*** APPROVED**
Engineering Department

**GEOTECHNICAL ENGINEERING STUDY
 PROPOSED MAYBERRY FILING 1A ROADWAYS
 EL PASO COUNTY, COLORADO**

***Approval does not include
 Village Main Street
 between New Log and
 Indian Grass (or any
 location where the new
 CD's may impact.**

EPC file no SF1825

FIG. 1 – LOCATION OF EXPLORATORY BORINGS

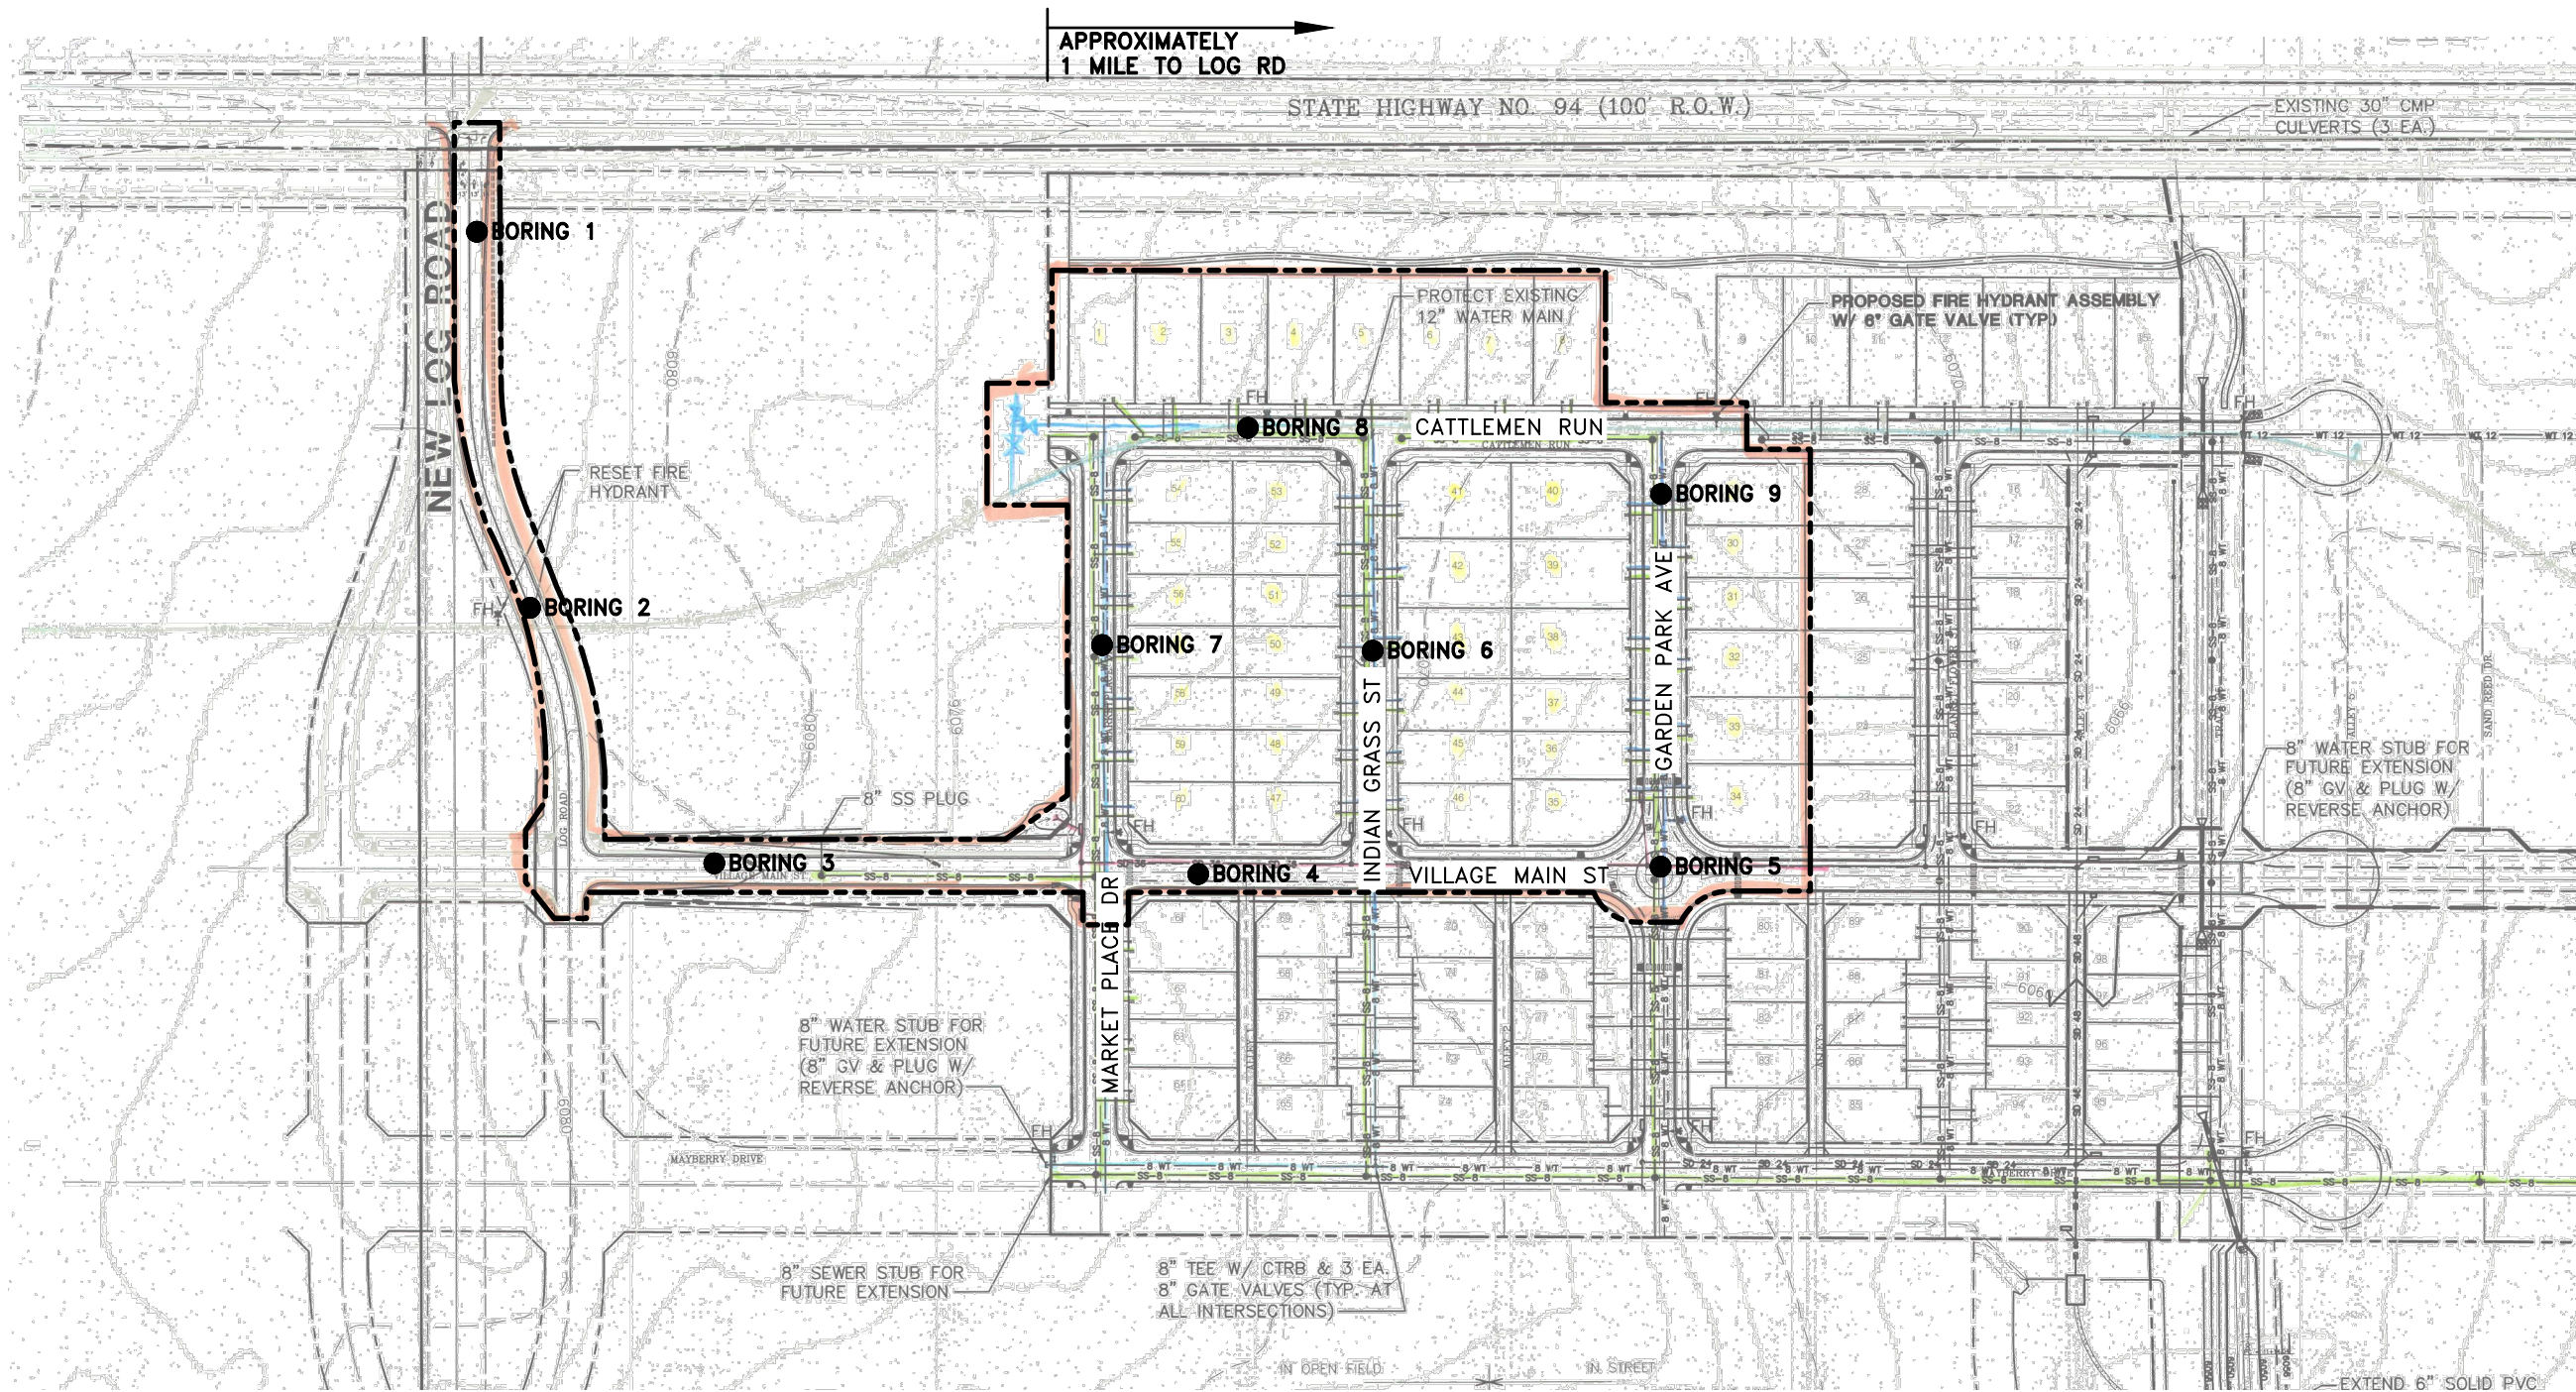
Approval does not include Village Main Street between New Log and Indian Grass.
